Rouge Park Bridges Transportation Master Plan

Phase 2 Consultation Report

January 23, 2023

Question 4) Do you agree with the recommendation to retain Sewell's Road Bridge?

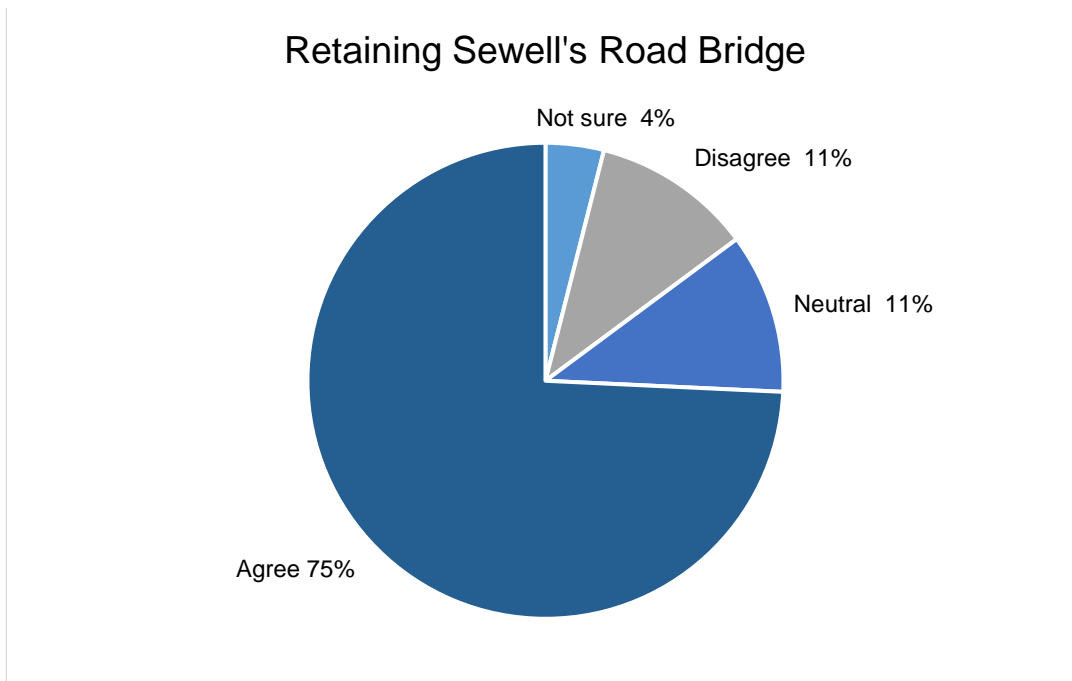
Comments about the recommendation for Sewell's Road Bridge:

- Maintain the historical structure and feel.
- Improve the aesthetics and add paint

- Make it structurally sound to last the next 50 years.
- Do not widen the bridge or the approach.
- Add signage to ensure drivers are aware it's a single lane bridge.
- Do not replace it – it's beautiful.

Question 5) Do you agree with the recommendation to replace Milne Bailey Bridge?

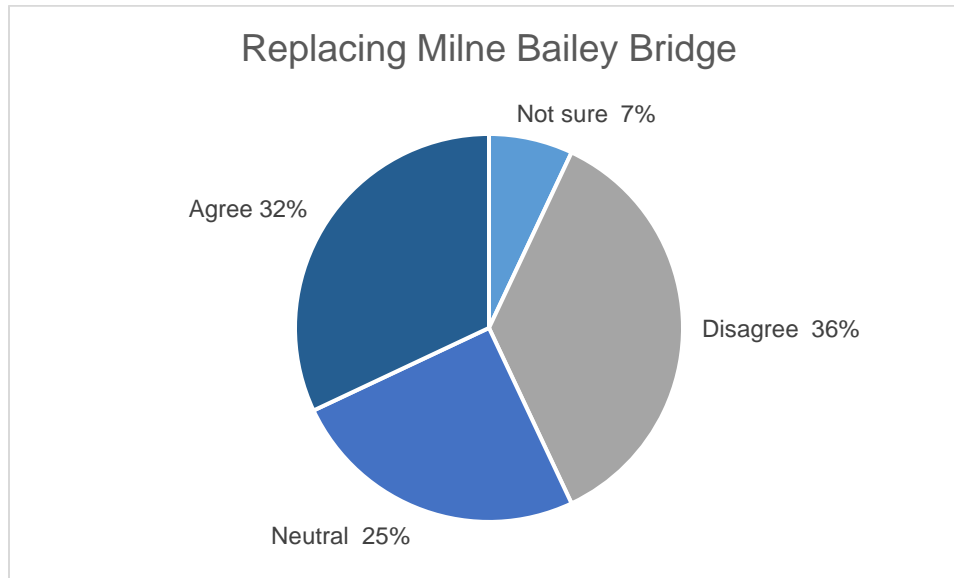
Comments about the recommendation for Milne Bailey Bridge

- Disagree with recommendation – retain instead:
 - o Prefer to retain it.
 - o Need it to get around in Hillside; traffic flow works well with traffic light.

- o Retain historical, unique, and significant characteristics.
 - o Make it structurally sound.
 - o Do not widen the bridge or the approach.
 - o Use as an education opportunity about how climate affects human settlements as this is a historic landmark built after hurricane Hazel.

- Agree with recommendation - replace:
 - o Deck is dangerous for people cycling and walking, especially when wet.
 - o Traffic light requires patience for people cycling.

- o It's old, in bad repair and been neglected far too long.
 - o Enable people cycling and walking to safely cross with a more modern bridge.
 - o Prioritize the movement of people cycling and walking instead of people driving and should be directed to use Steeles Ave and Sheppard Ave to travel across the area.

Question 6) Do you agree with the recommendation to replace Hillside Bridge?

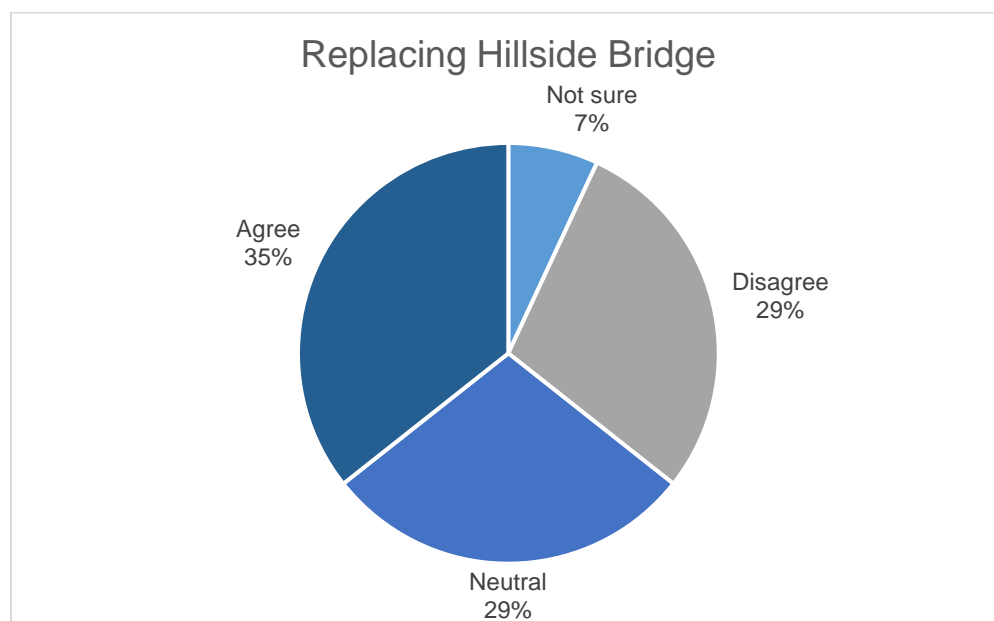
Comments about the recommendation for Hillside Bridge

- Disagree with recommendation – retain instead:
 - o Keep its characteristics and historical feel with minimal changes.
 - o Make it more structurally sound, maintain and upgrade it.
 - o Do not increase traffic on it.
 - o Do not widen the bridge or the approach.
 - o Keep one-way bridge – they are unique to the area and help to slow down traffic.

- Agree with recommendation - replace:
 - o Prioritize the safety of people cycling and walking – they have had serious accidents on the platform/mesh deck.
 - o Install traffic lights, especially to direct traffic for people cycling.

Question 7) Do you agree with the recommendation to retain Maxwell Bridge?

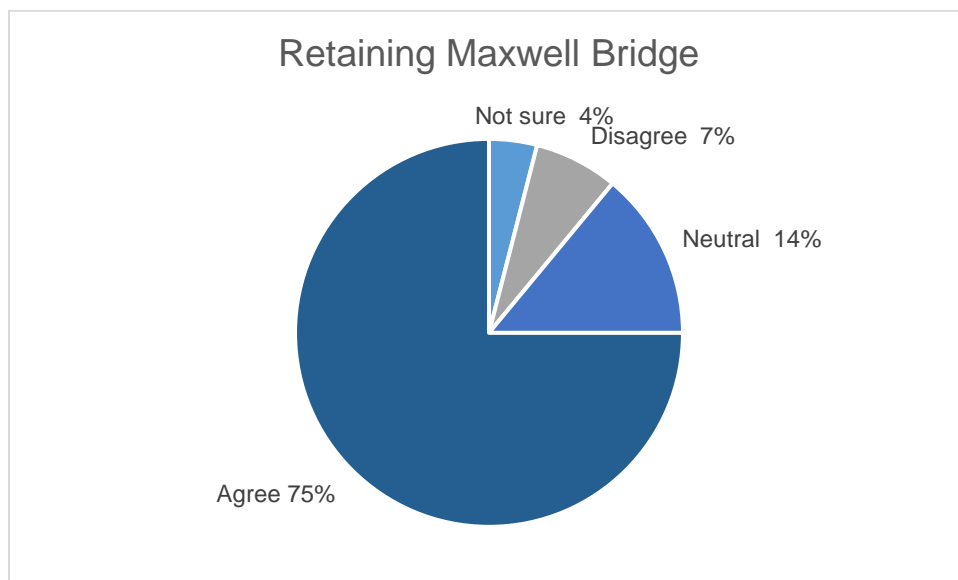
Comments about the recommendation for Maxwell Bridge

- Prioritize safety for people walking.
- Retain its characteristics and historical feel.
- Make it structurally sound.
- Do not widen bridge or the approach.
- Divert people hiking from this bridge crossing.
- Protect wildlife.
- Vehicle travel:
 - o Close access from the Pickering side of Twyn Rivers Drive to eliminate traffic and make it more pedestrian friendly.
 - o Limit vehicle speeds.
 - o Discourage commuters using the park to cut through.
 - o Do not increase traffic.
 - o Do not remove this bridge or Twyn Rivers Drive becomes redundant.

Question 8) Do you agree with the recommendation to replace Stotts' Bridge?

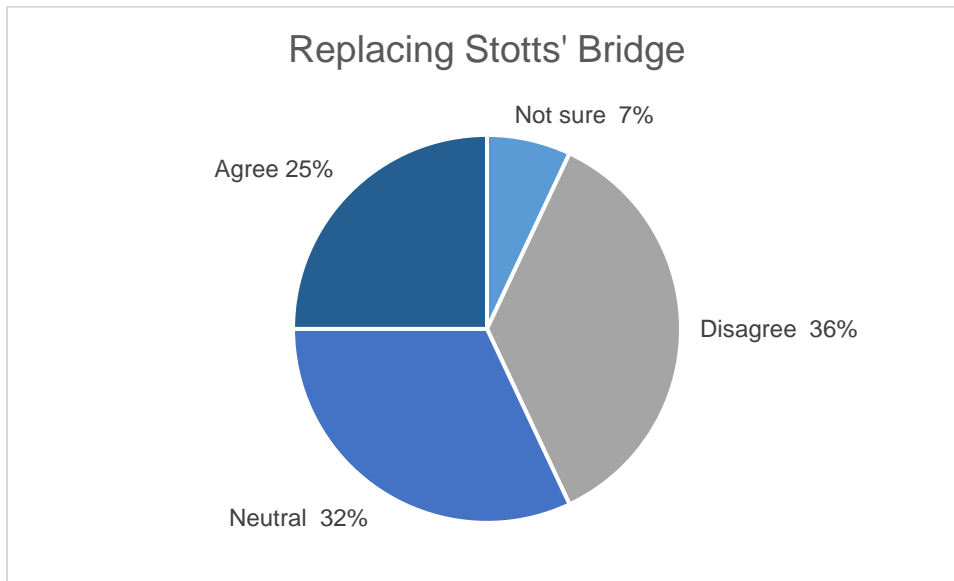
Comments about the recommendation for Stotts' Bridge:

Disagree with recommendation – retain instead:

- Reduce speed and excess traffic by keeping the one-way bridge at the bottom of a hill.
- Keep its characteristics, including narrow form and historical feel.
- Make it structurally sound and upgrade it.
- Do not increase traffic – will increase pollution.
- Do not widen the bridge or the approach.
- Improve upon previous repairs completed a few years ago.
- Prioritize wildlife and recreation, not commuters.
